| IN no.: IN-152 rev 1.0.1 | Date: 2022-02-07 (rev), 2021-12-14 (initial) |
| Device affected: nRF52810-QFAA, nRF52810-QCAA and nRF52810-CAAA | Device version / Build Code: Dx0 |

Description of change:

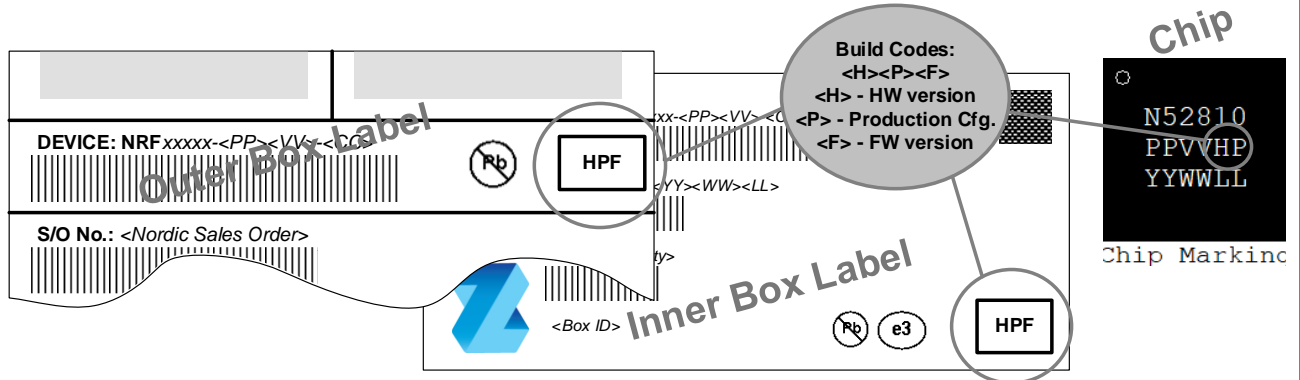
If an nRF52810 revision 3 is programmed with software compiled with a version of the MDK prior to release 8.43.0, the debug port will be locked. However, the APPROTECT.FORCEPROTECT will not be written to Force (0x0), and the errata workarounds implemented in the MDK may not be applied to revision 3. Thus, it is required to upgrade to the latest MDK (version 8.43.0 or later) to ensure correct behavior.
